HISTORIC AND DESIGN REVIEW COMMISSION

HDRC CASE NO: 2021-225
ADDRESS: 714, 716, 718 LABOR ST
LEGAL DESCRIPTION: NCB 3003 BLK 1 LOT N 70.89 FT OF 1
ZONING: C-2NA, H
CITY COUNCIL DIST.: 1
DISTRICT: Lavaca Historic District
APPLICANT: Anthony Guajardo/Clearsite Construction
OWNER: GUAJARDO J ANTHONY CHILD TR
TYPE OF WORK: Roof replacement and pitch changes
APPLICATION RECEIVED: June 04, 2021
60-DAY REVIEW: Not applicable due to City Council Emergency Orders
CASE MANAGER: Edward Hall

Historic and Design Review Commission
Design Review Committee Report

MAIN LEVEL
FLOOR PLAN,
ELEVATIONS

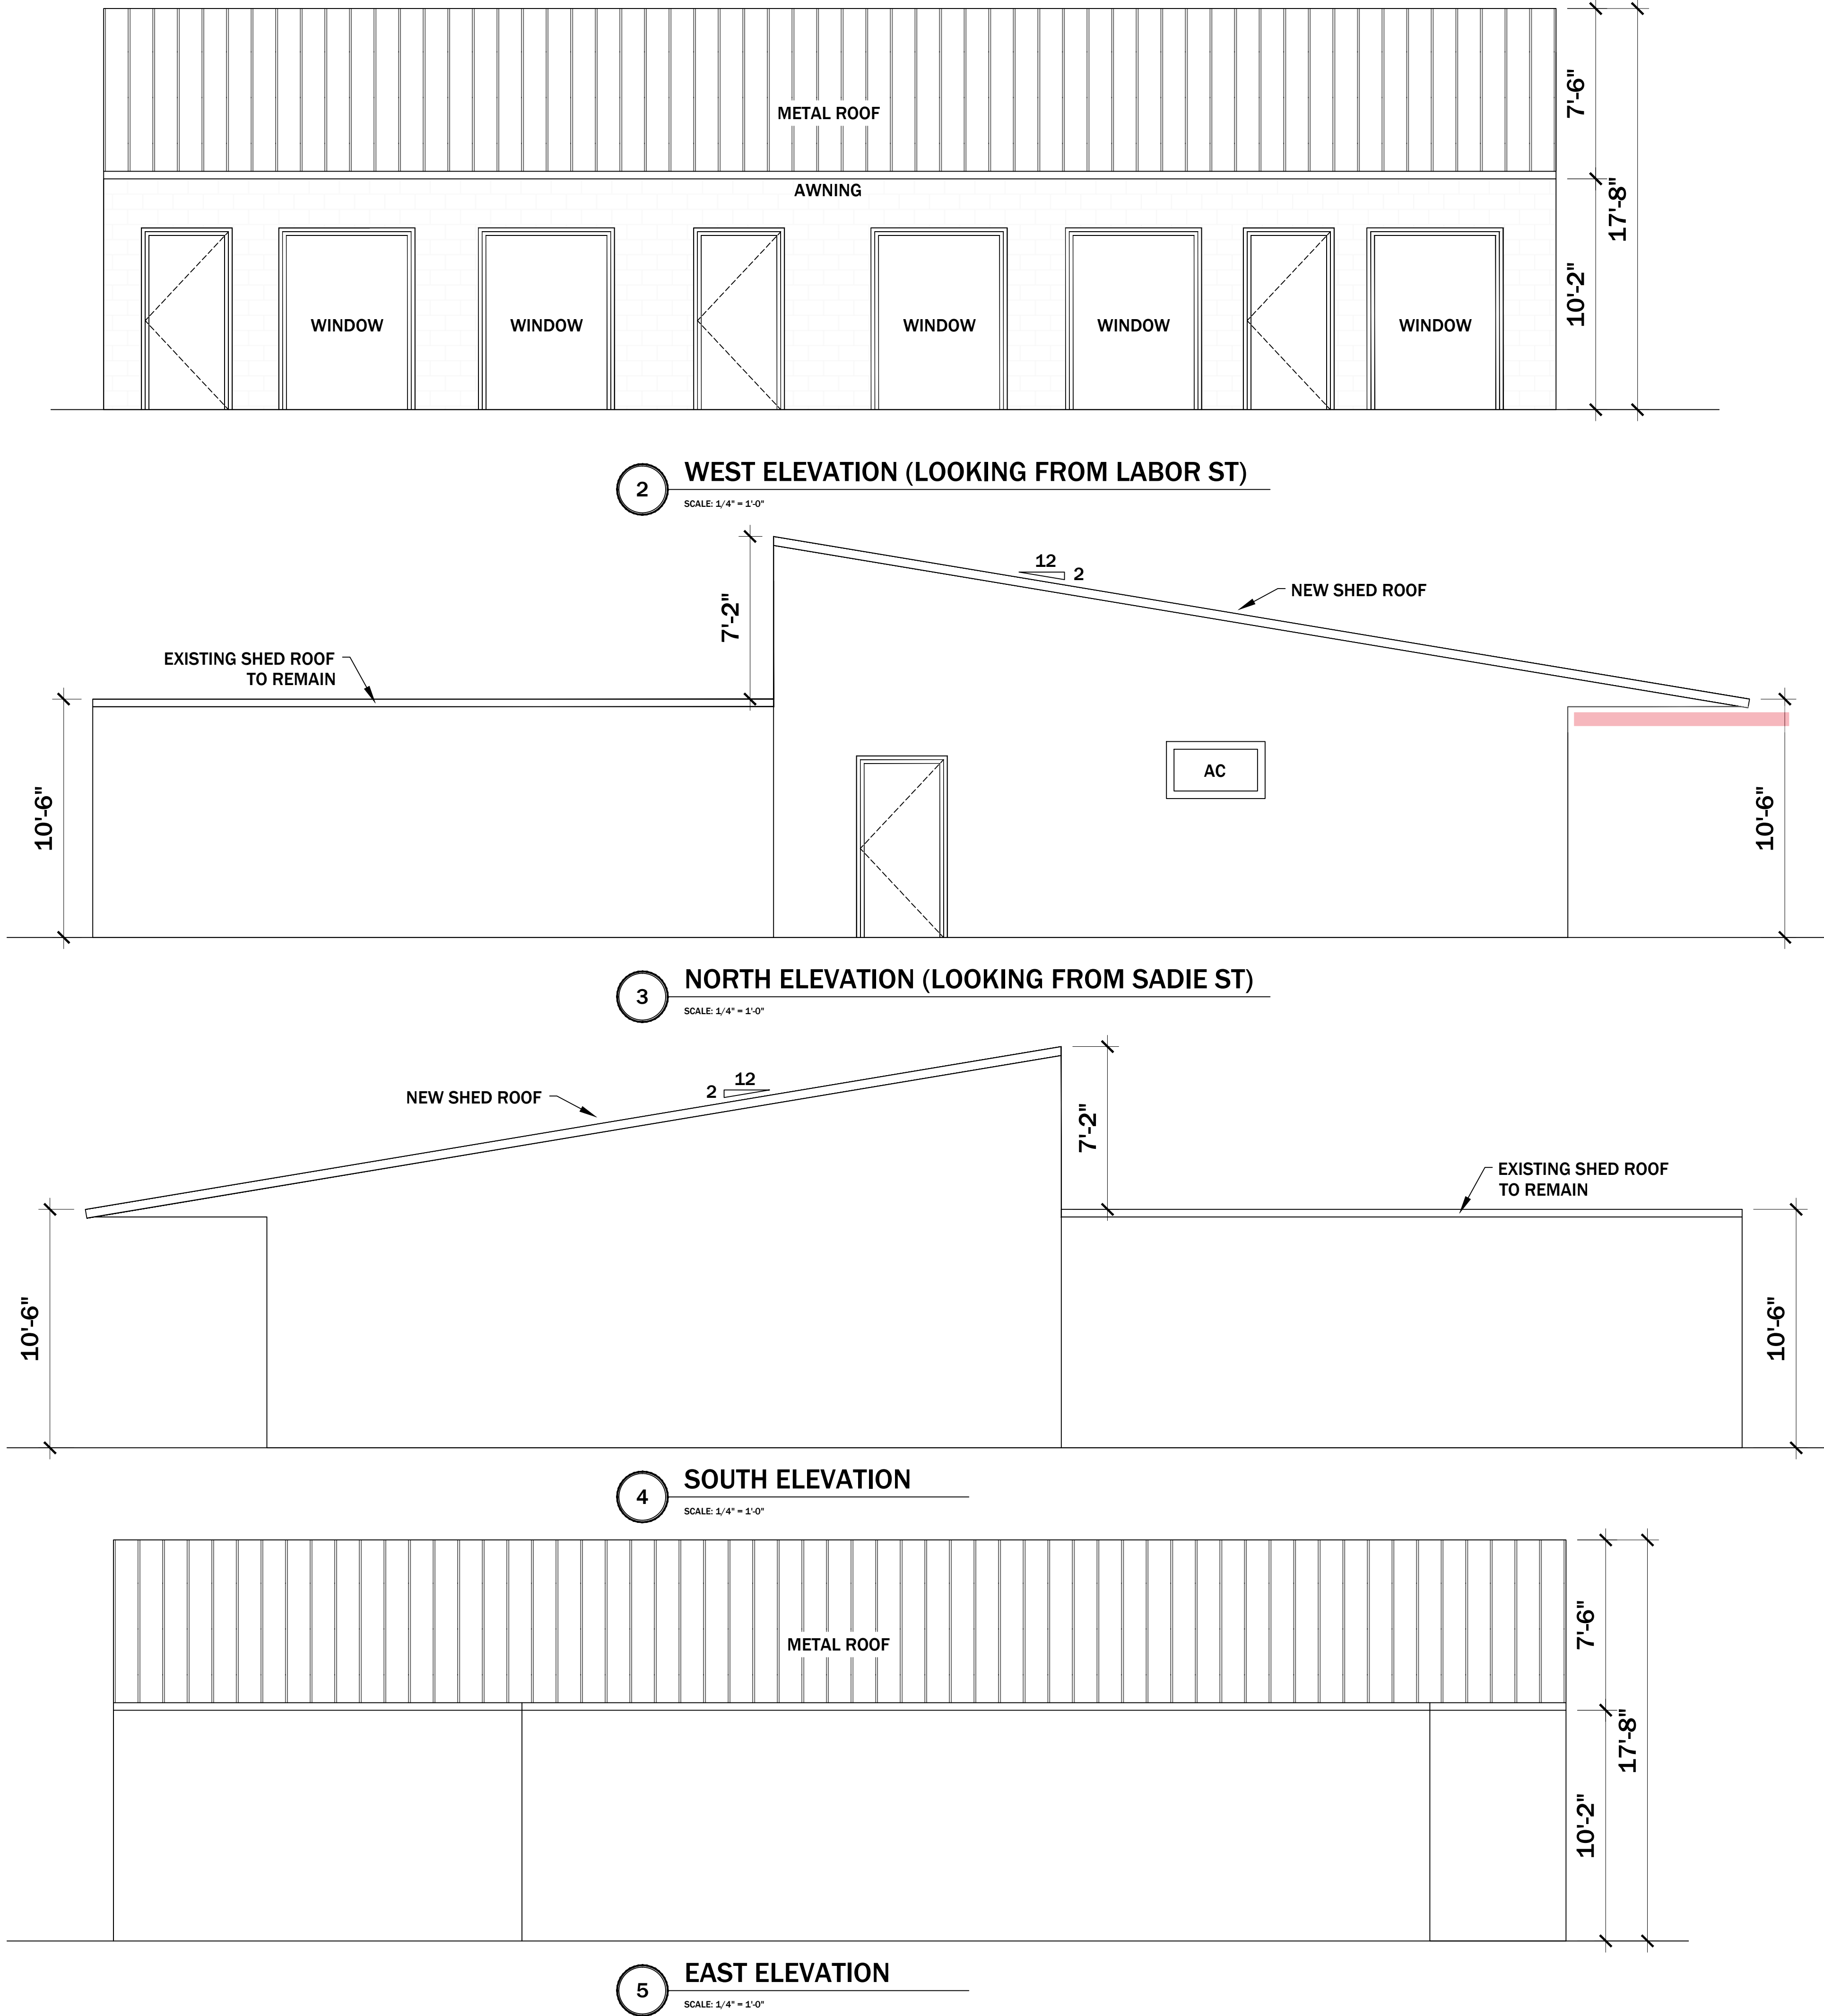
GV: questioned if the slope was minimal amount required for drainage, noted that the proposed form is characteristically different from the previous condition and similar commercial structures of the age/style in the district.

JF: Noted that low slope/flat roofs with bitumen cover are commonly repaired on commercial structures and that change in roof for is atypical. Suggested removing the failing roof plate on the canopy plane and dropping the trusses so that there would be no double eave/canopy condition. Also suggested exploration restoring the low pitch gable as evident in the side elevation profile, to which the applicant noted would not be feasible due to the rear addition. Also questioned the consistency of the request regarding metal or shingle finish which may alter the required slope for drainage.

Staff does not recommend approval based on finding e. Staff recommends in-kind repairs of the existing roof structure.
